**Addendum No. 2
February 16, 2023**

Project: Harrisburg Elementary School #8
Harrisburg, South Dakota
Architecture Incorporated Project #3000

Architect: Architecture Incorporated

2.40

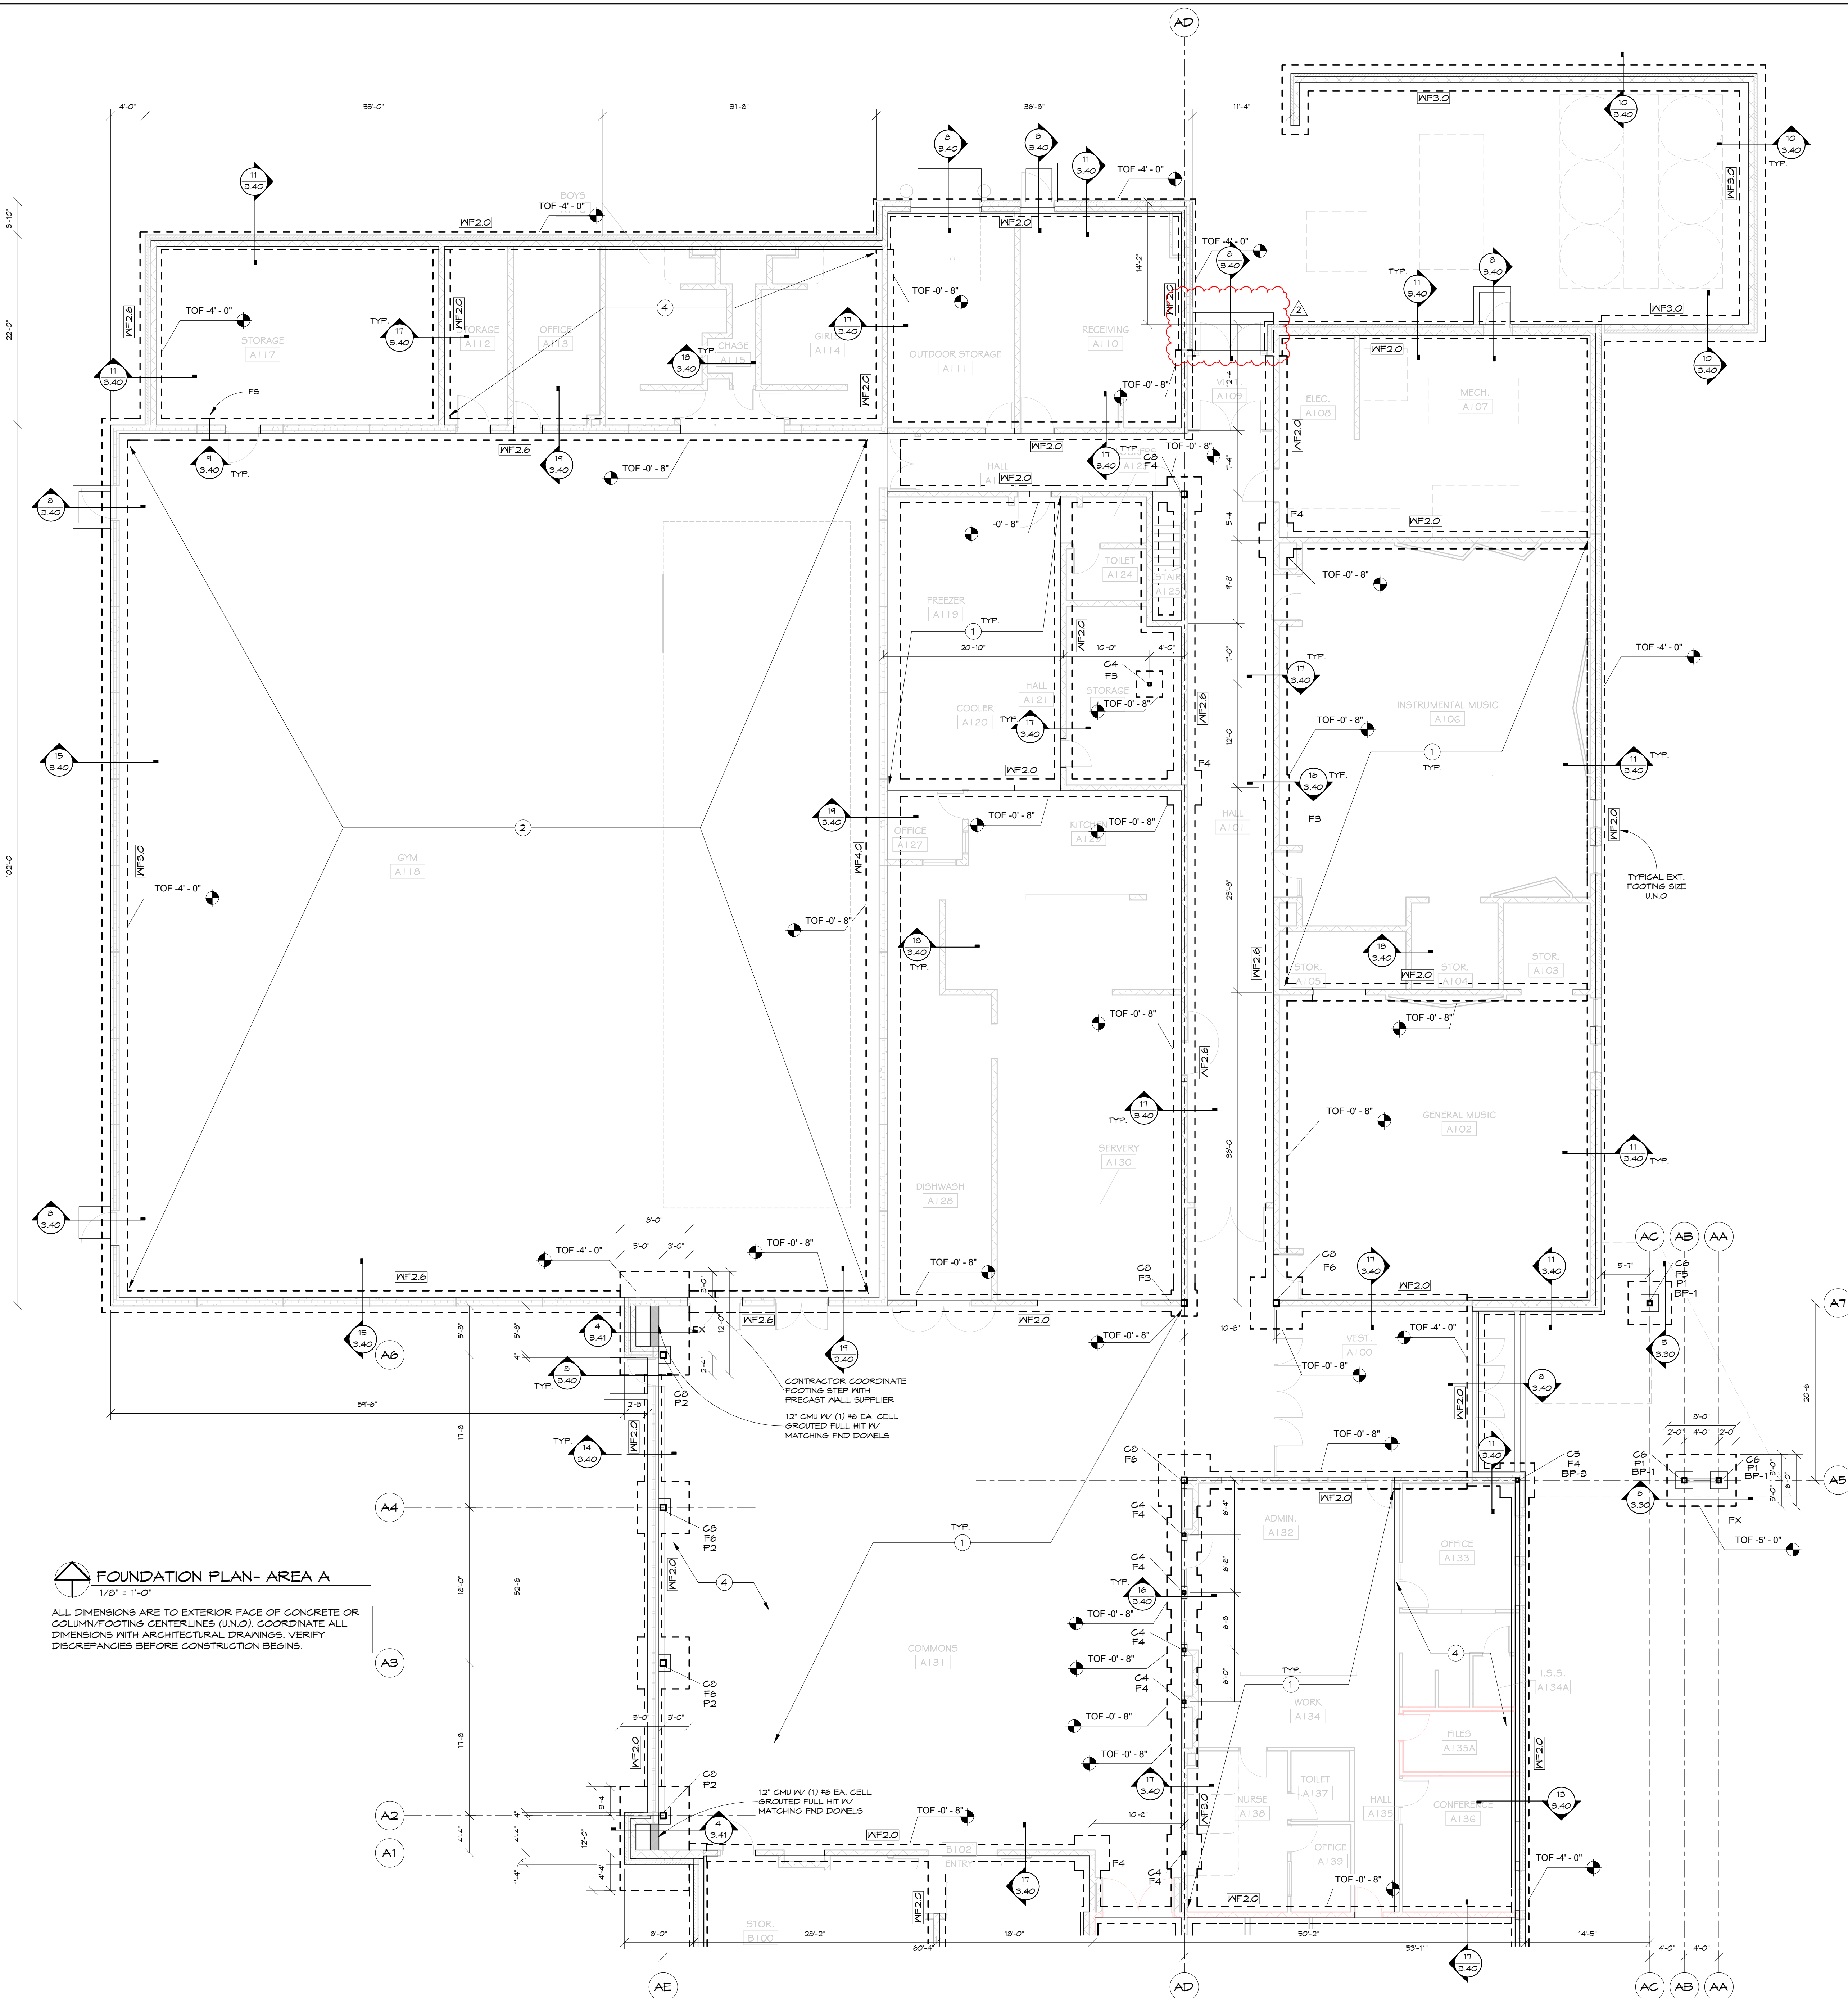
- a) Adjust the location of the main parking lot driveway as indicated per *revised* civil drawing Sheet 2.40, dated 2-16-23, attached to the end of this addendum.
 - i) Location of driveway has been shifted approximately 70' east to align with future S. Shebal Avenue.
 - (1) The driveway width has also increased to provide for an inbound lane, an outbound left turn lane and an outbound right turn lane onto Twin Creeks Drive.
- b) Provide an 8'-0" wide x 4-inch thick strip of concrete sidewalk adjacent the west side of the 20'-0" wide playground driveway as indicated per *revised* civil drawing Sheet 2.40, dated 2-16-23, attached to the end of this addendum.

3.20-1A

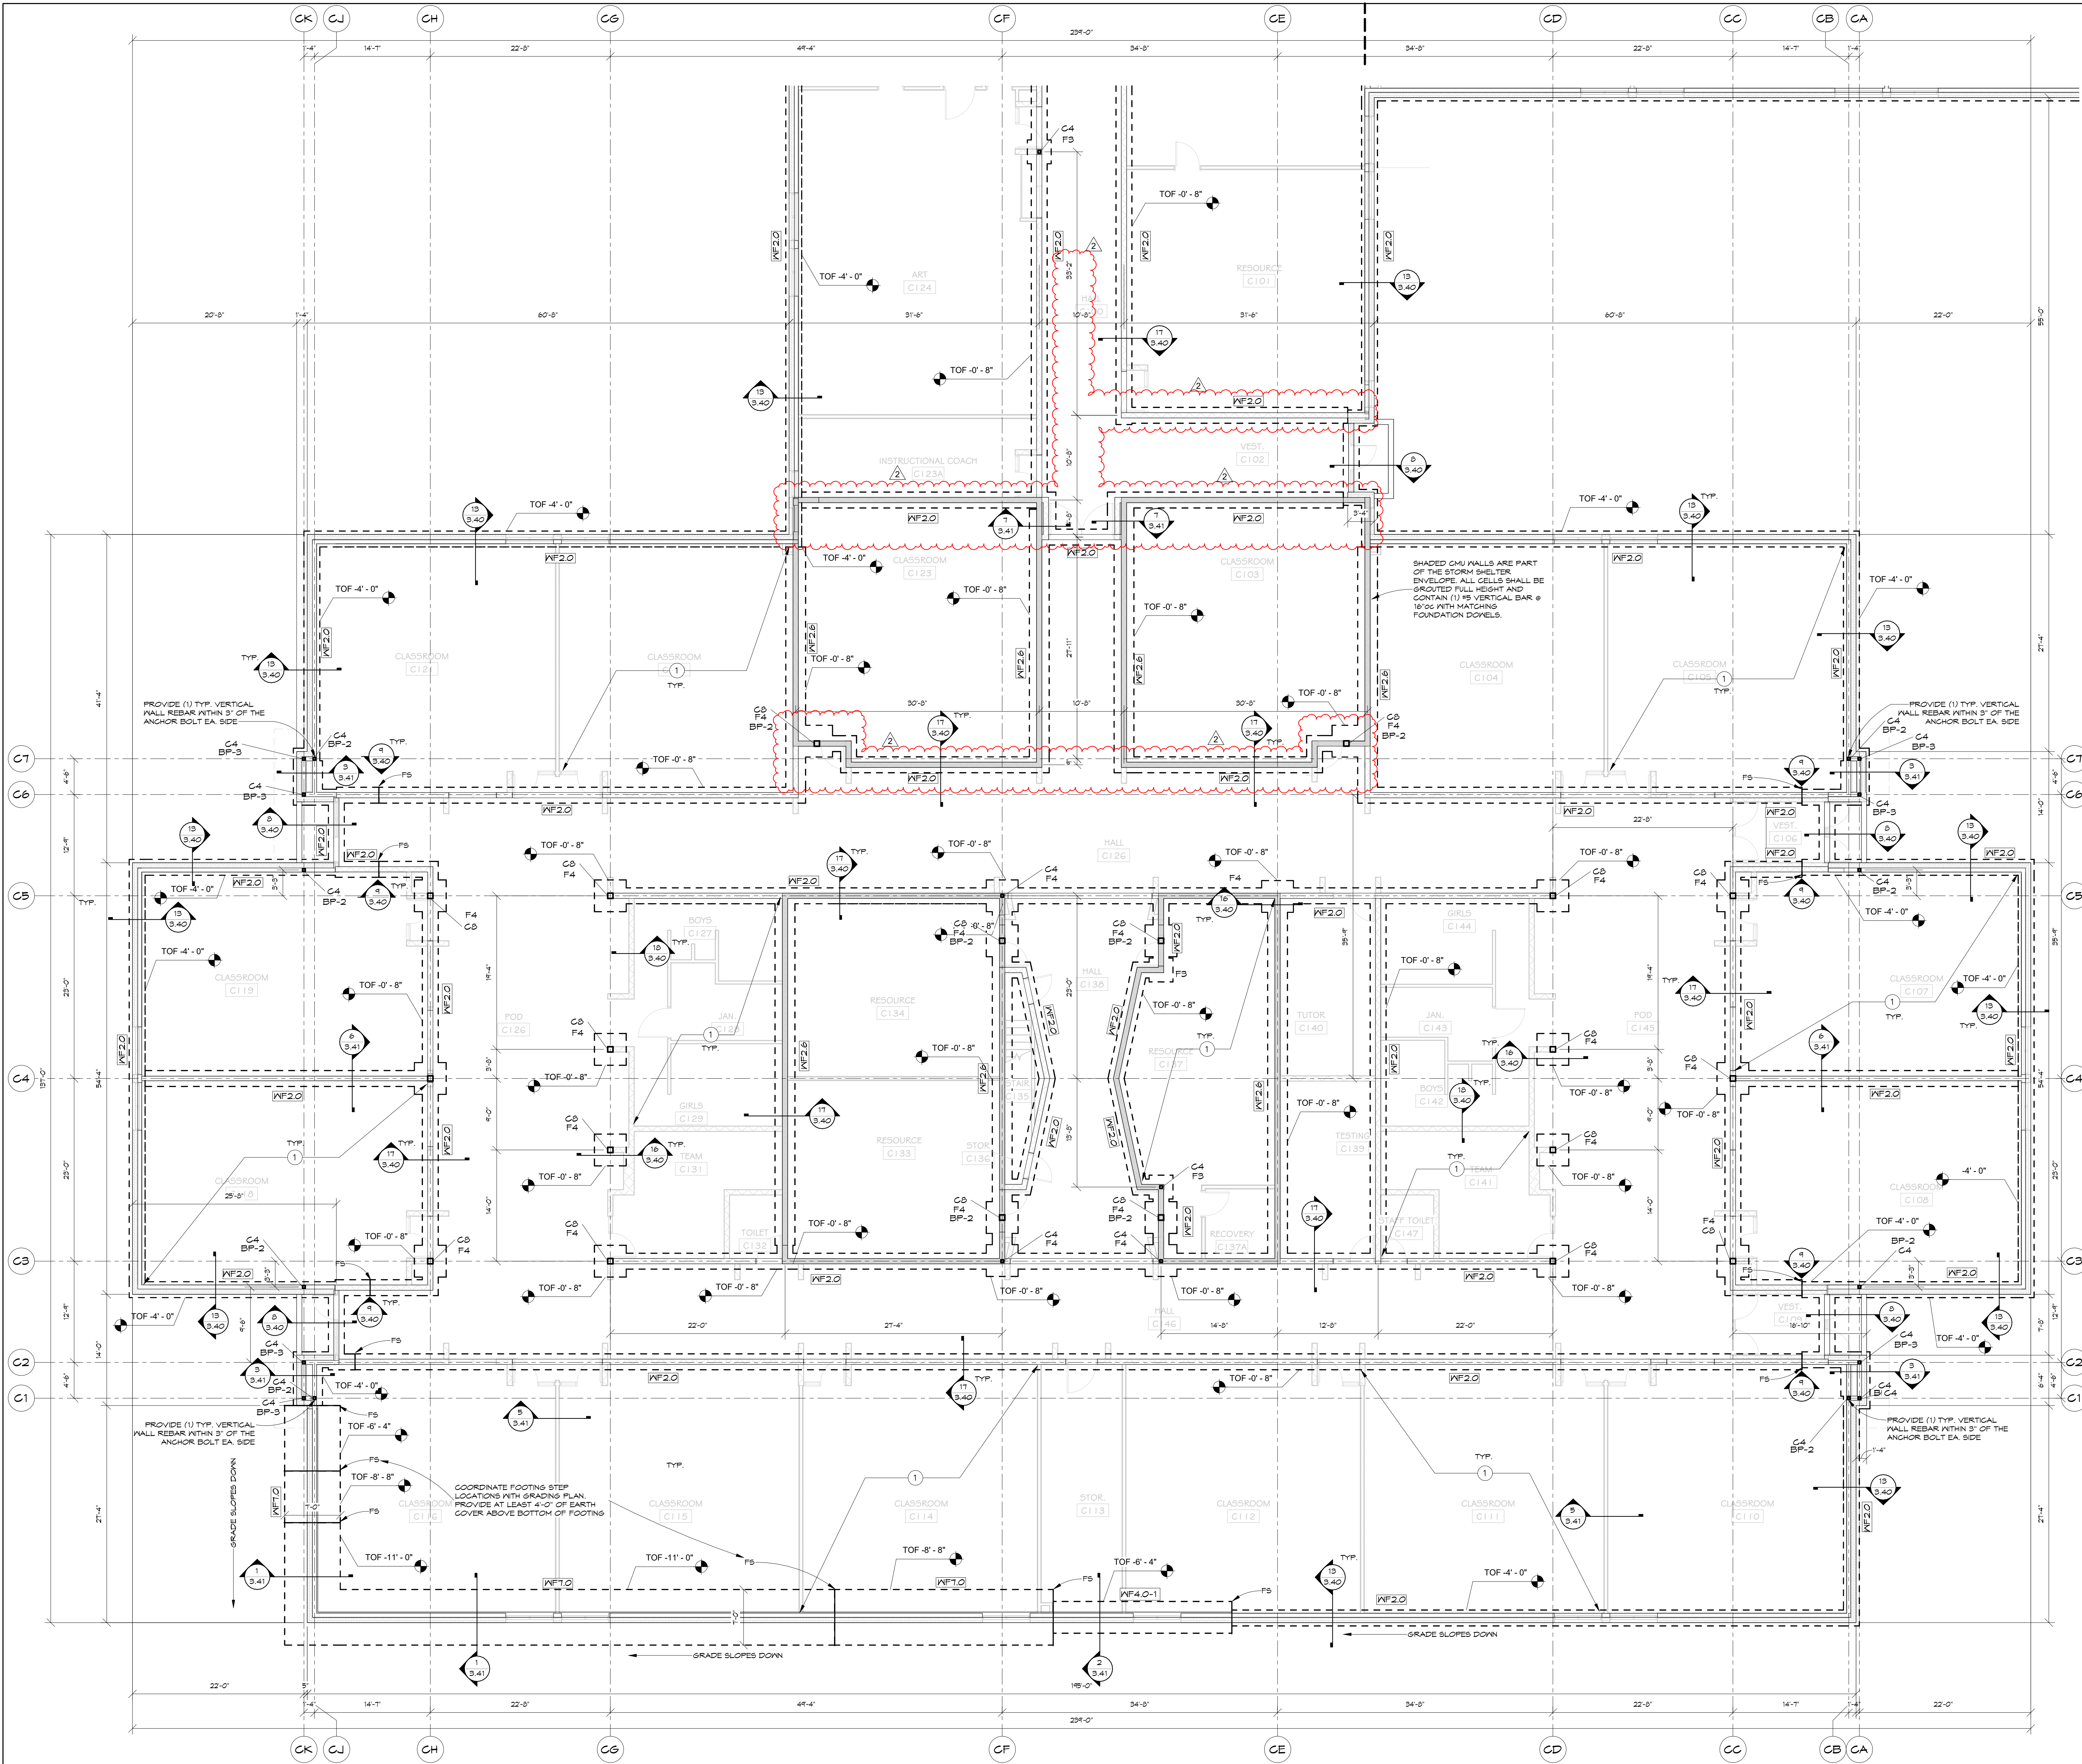
- a) Omit the concrete stoop shown immediately north of overhead door opening A111-1; not required.
- b) Modify stoop position at VEST A109 per clouded area on *revised* structural drawing Sheet 3.20-1A, dated 2-16-23, attached to the end of this addendum.

ROOF FRAMING PLAN- AREA A
1/8" = 1'-0"

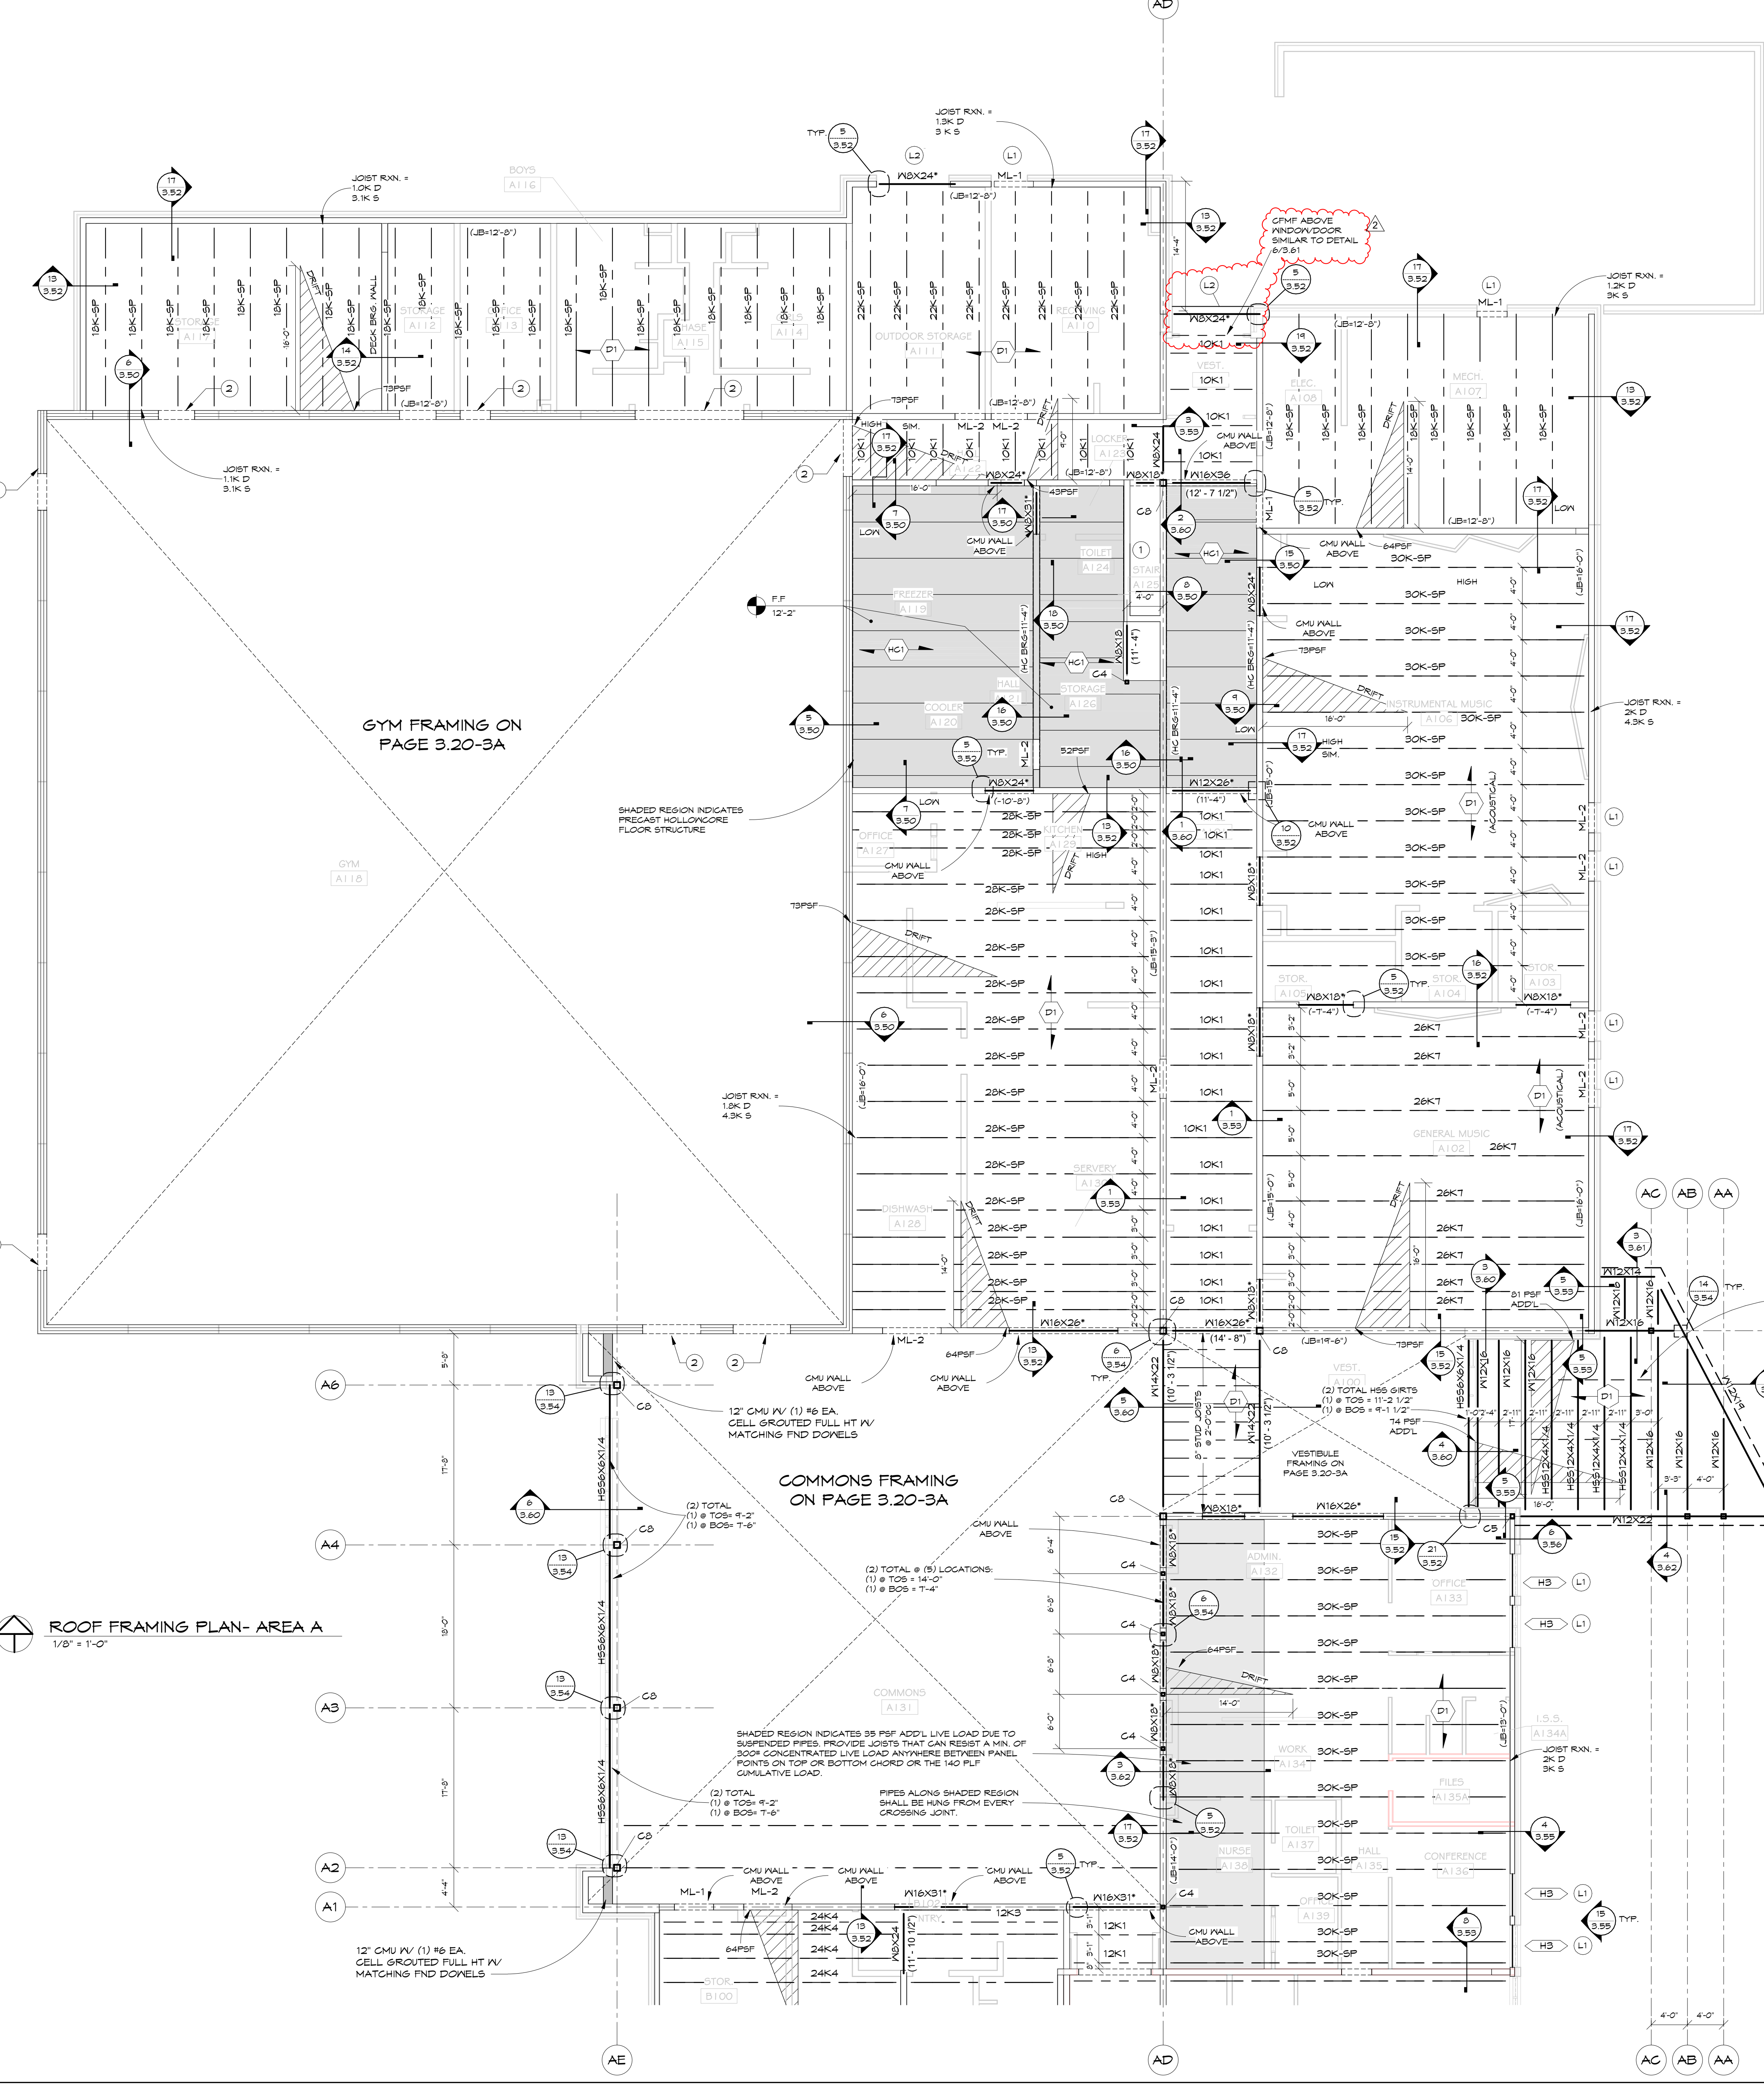
- a) Modify framing at entrance to VEST A109 per clouded area on *revised* structural drawing Sheet 3.20-2A, dated 2-16-23, attached to the end of this addendum.
